TECHNICAL BULLETIN

FA-A-0345-A

Change of Brightness of the Print Characters on the MELSEC-Q Series Large Type Input Modules

QX11L and QX21L

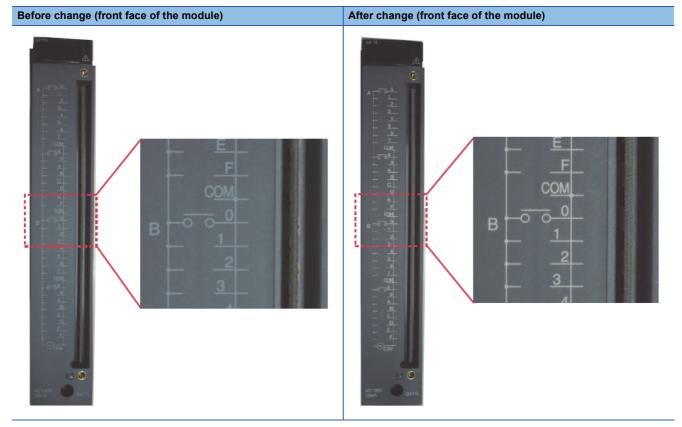
We are informing you that the brightness of the characters printed on the front face of large type input modules are to be changed.

The characters on the front face of the module are to be printed with a brighter color.
